Re: Whitehorse Urban Cycling Coalition Input to Two Mile Hill & Range Road Intersection

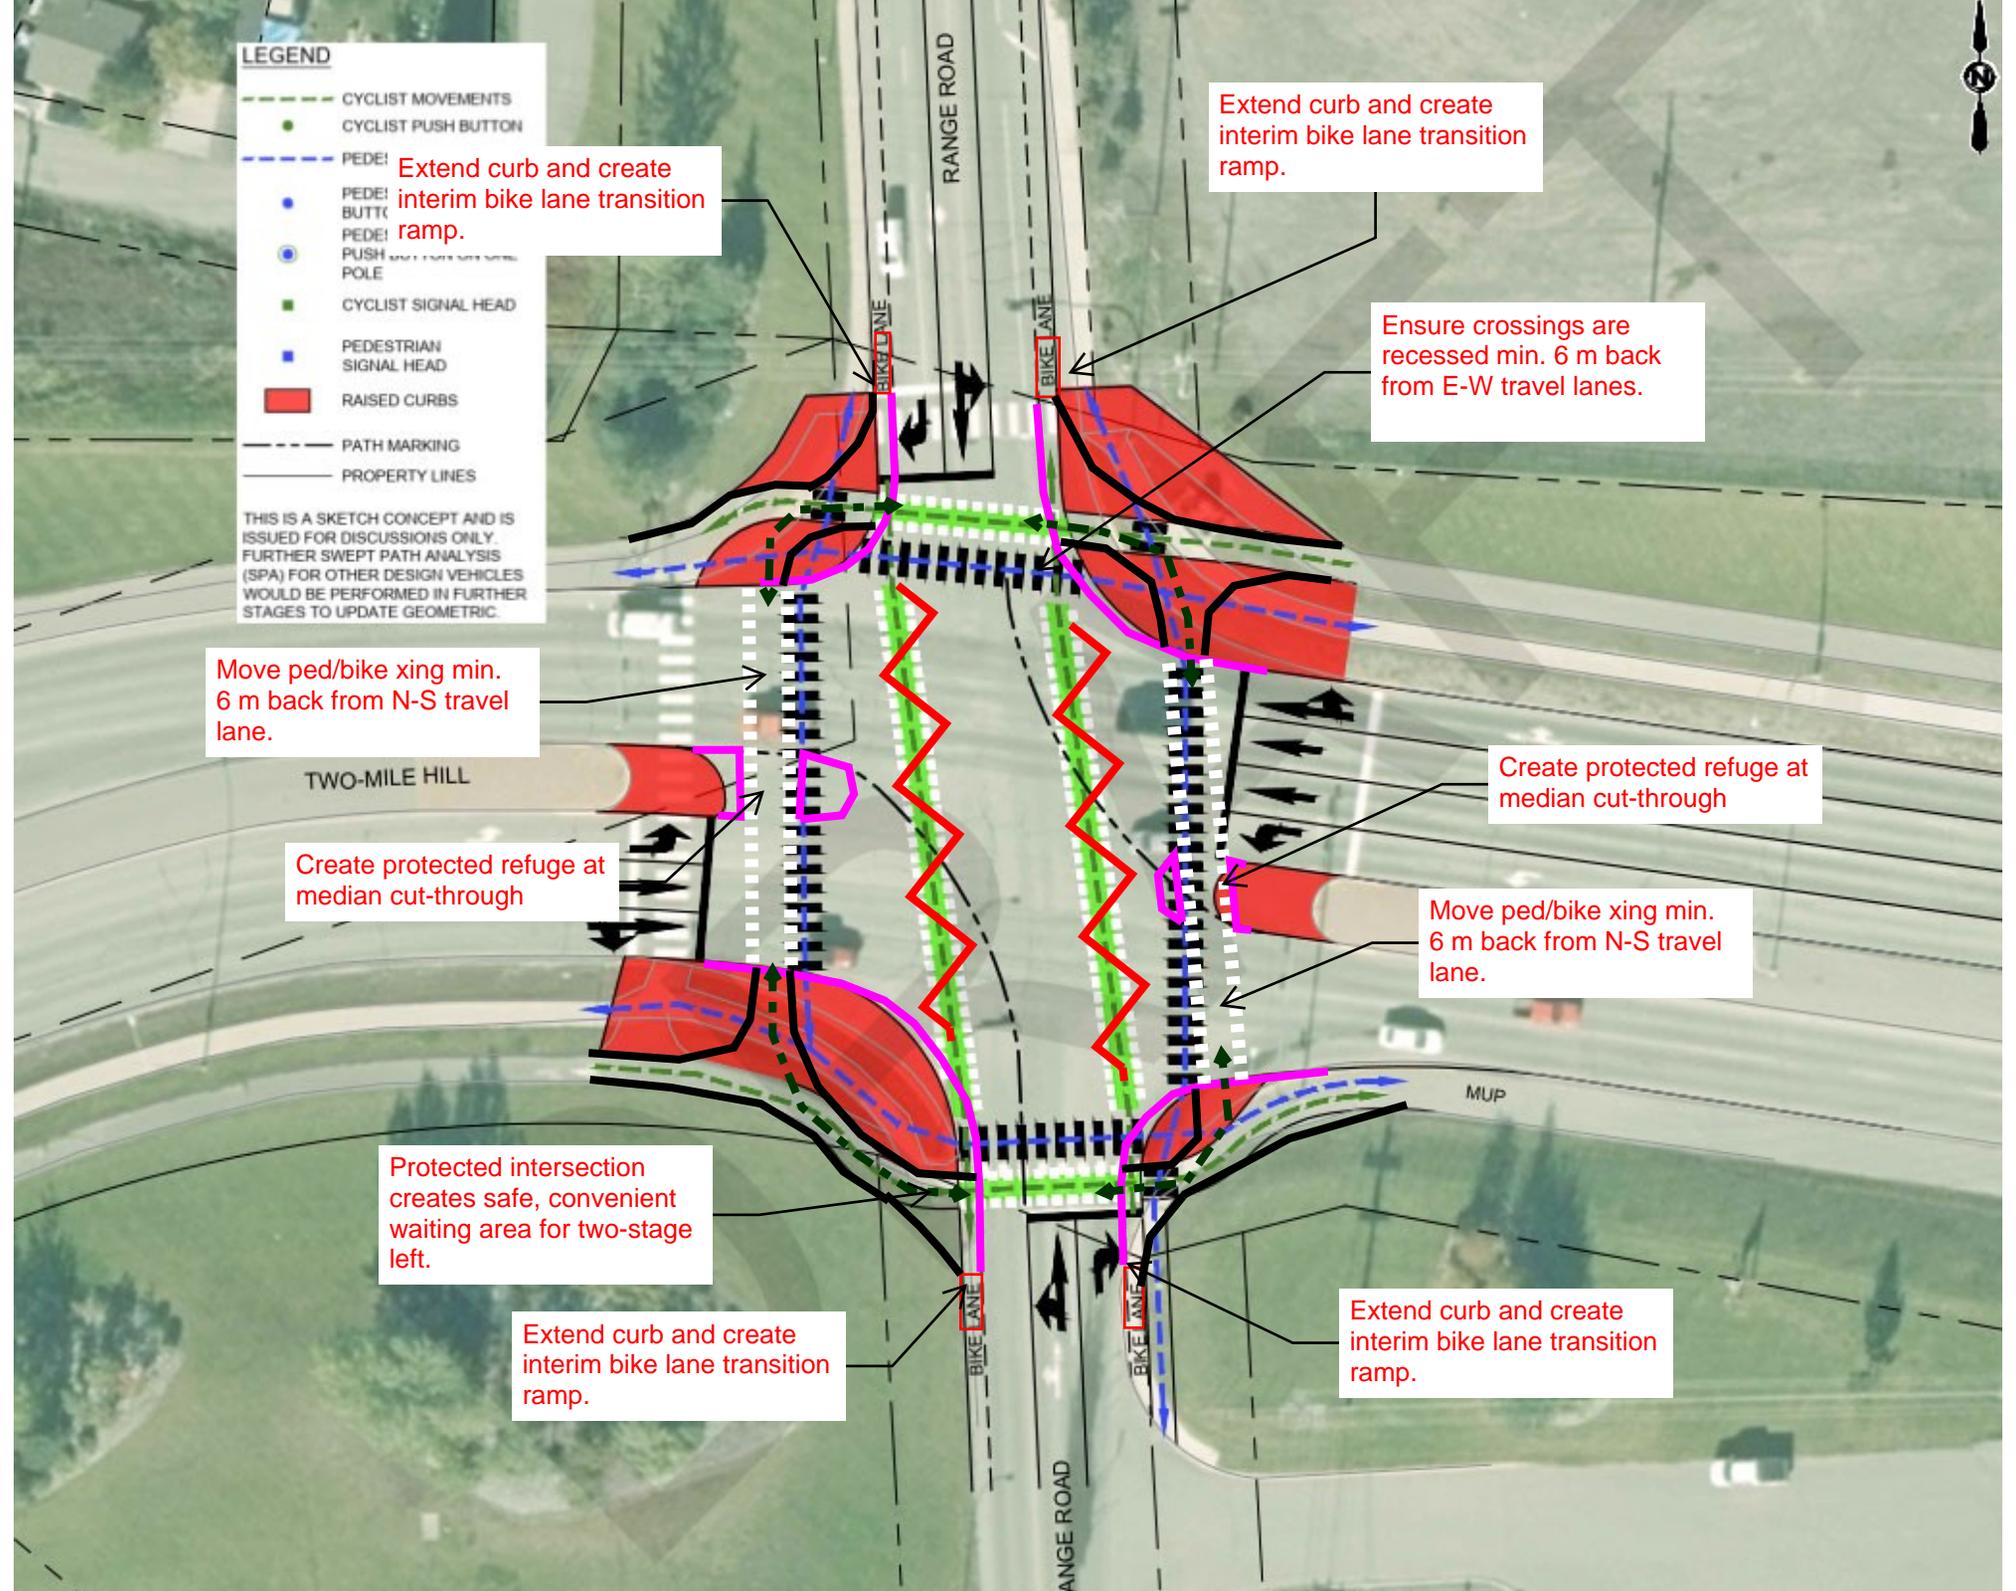
To “get it right” for cyclists and pedestrians at this intersection, a protected crossing design is needed for north-south crossings, similar to what has been proposed for the east-west crossing of this intersection. This will bring a contemporary design that has been proven to be safer and more accessible to cyclists. Because the design of the AAA infrastructure on Range Road is not yet known, using a protected crossing of Two Mile Hill will “future proof” the intersection as it will accommodate any protected design north and south of Two Mile Hill. In the interim, the current “bike lanes” on Range Road north can be transitioned with a curb extension and mounting ramp north of Two Mile Hill that will convey cyclists on Range Road north on to (or from) the protected crossing of Two Mile Hill. A sketch of this accompanies this letter.

Extend curb and create interim bike lane transition ramp.

Ensure crossings are recessed min. 6 m back from E-W travel lanes.

Move ped/bike xing min. 6 m back from N-S travel lane.

Create protected refuge at median cut-through

Create protected refuge at median cut-through

Move ped/bike xing min. 6 m back from N-S travel lane.

Protected intersection creates safe, convenient waiting area for two-stage left.

Extend curb and create interim bike lane transition ramp.

Extend curb and create interim bike lane transition ramp.
